4 -----X
5 In re: Docket Nos. 50-247-LR; 50-286-LR
6 License Renewal Application Submitted by ASLBP No. 07-858-03-LR-BD01
7 Entergy Nuclear Indian Point 2, LLC, DPR-26, DPR-64
8 Entergy Nuclear Indian Point 3, LLC, and
9 Entergy Nuclear Operations, Inc. September 9, 2015
10 -----X

11 PRE-FILED SUPPLEMENTAL REPLY WRITTEN TESTIMONY OF

12 Dr. RICHARD T. LAHEY, JR.

13 REGARDING CONSOLIDATED CONTENTION NYS-26B/RK-TC-1B

Figure 1: Comparison of Limit Line (LL) and Best Estimate (BE) predictions, with embrittlement (BE_e) and without embrittlement (BE_{ne}).

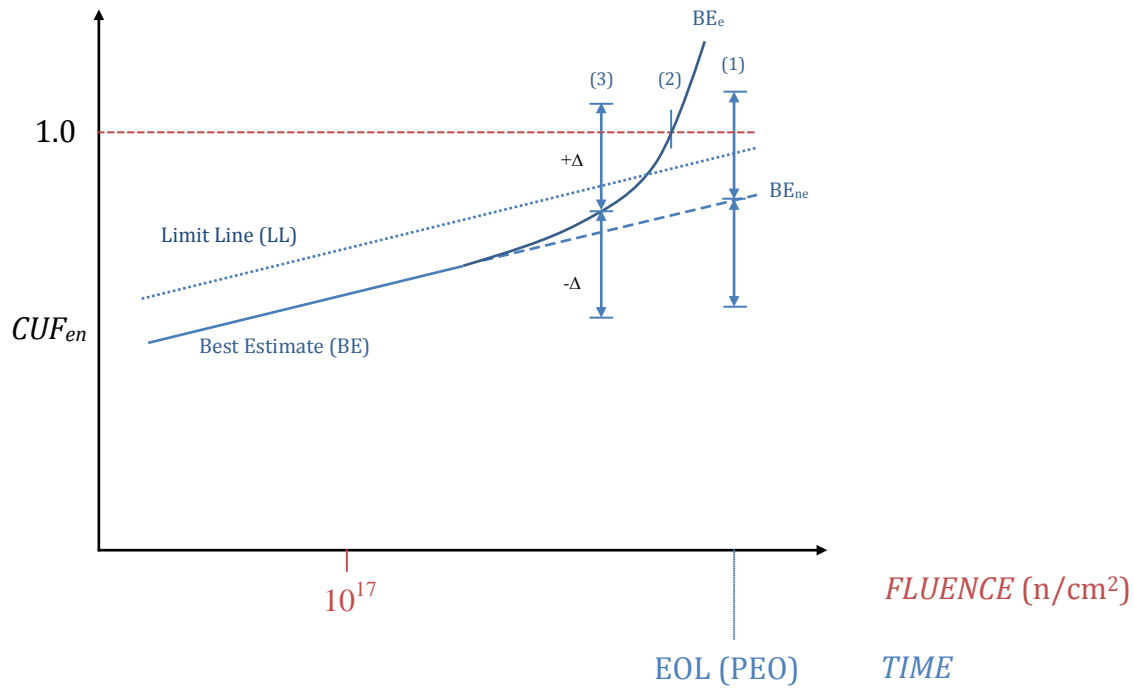
- (1) BE_{ne} predicts possible failure at end of life (EOL).
- (2) BE_e predicts failure (CUF_{en} = 1.0) before end of life.
- (3) BE_e predicts possible failure well before end of life.

1 uncertainty interval (Δ), and, (3) how the neutron fluence-
2 induced embrittlement of a RVI structure, component, or fitting
3 can dramatically increase the possibility of a fatigue failure,
4 as represented by the cumulative usage factor under PWR
5 operating conditions, CUF_{en} , being equal to unity. This figure
6 applies to RVI structures, components, and fittings made of
7 stainless steel or other materials. In summary, in Figure-1, I
8 have illustrated two different approaches for calculating a
9 time-dependent CUF_{en} , namely the "Limit Line" and the "Best
10 Estimate" calculation. For the "Best Estimate" line, I also
11 illustrate typical uncertainty intervals, delta (Δ), and the
12 effects of fatigue on embrittled (e) and on non-embrittled (ne)
13 RVIs.

17 [REDACTED]
18 [REDACTED] The "Limit Line" shown in Figure-1 includes
19 Entergy's implicit assumption that a stainless steel RVI
20 structure, component, or fitting remains perfectly ductile, and
21 thus shows that the CUF_{en} for a RVI will increase with an
22 increasing number of fatigue cycles, but that it is not affected
23 by the fluence. The "Limit Line", therefore, uniformly

1 increases in CUF_{en} even after the fluence exceeds 10^{17} n/cm²,
2 where significant embrittlement begins to develop (i.e., it is
3 assumed that the number of cycles to failure are not a function
4 of fluence). Figure-1 shows that, as the RVI component
5 approaches the end of life (EOL) for the period of extended
6 operation (PEO), [REDACTED] "Limit Line" will approach
7 (but still be below) $CUF_{en} = 1.0$. This is depicted as location
8 (1).

11 A. Not necessarily. As shown in Figure-1, a "Best
12 Estimate" prediction plus the uncertainty (Δ) may predict
13 possible RVI structure, components or fitting failures (i.e.,
14 $CUF_{en} = 1.0$), sooner than the "Limit Line" would. Moreover, the
15 effect of embrittlement can make the situation much worse. The
16 problem is that no one knows how much conservatism, if any, is
17 in the [REDACTED] "Limit Line". As a consequence, we can have no
18 confidence that "Limit Line" results near $CUF_{en} = 1.0$, are
19 sufficiently conservative to bound all the possible
20 uncertainties, as illustrated in Figure-1 by Δ .

20 A. Location (1) shows that, even if embrittlement is not
21 considered, RVI fatigue failure may occur by the end of life for
22 the period of extended operation. This is because the sum of a

1 "Best Estimate" prediction plus the uncertainty interval (Δ)
2 associated with this prediction would exceed $CUF_{en} = 1.0$. In this
3 case the "Limit Line" result is clearly non-conservative.

6 A. Location (2) shows that embrittlement can result in
7 the physical failure of the RVI well before the end of life for
8 the period of extended operation.

11 A. At location (3), the "Best Estimate" plus uncertainty
12 (Δ) for the case considering embrittlement (BE_e) predicts
13 possible failure of the hypothetical RVI component well before
14 the end of life for the period of extended operation, even
15 though the "Limit Line" prediction indicates substantial margin
16 to failure at this point. That is, at location (3) the CUF_{en} for
17 the "Best Estimate" line, accounting for embrittlement and for
18 all uncertainties (i.e., $BE_e + \Delta$), exceeds unity. Moreover, as I
19 have stated in my previous testimony, highly embrittled RVIs may
20 fail even sooner than by fatigue alone if significant seismic or
21 shock loads occur. That is, fatigue-weakened and embrittled
22 structures cannot tolerate large impulsive seismic and shock
23 loads like fully ductile structures can. Moreover, other

1 synergistic aging effects, such as the thermal embrittlement (TE)
2 of some CASS RVIs (the upper part of the core support columns)
3 would may move the BE_e curve to the left of its position shown in
4 Figure-1 (i.e., the RVI would be predicted to reach failure,
5 $CUF_{en} = 1.0$, even sooner than the cases (2) and (3) in Figure-1).

8 A. Yes. Because of Entergy's failure to explicitly
9 account for uncertainties, and for the effect of embrittlement
10 on fatigued RVIs, we can have no confidence in the "Limit Line"
11 type of CUF_{en} predictions [REDACTED]
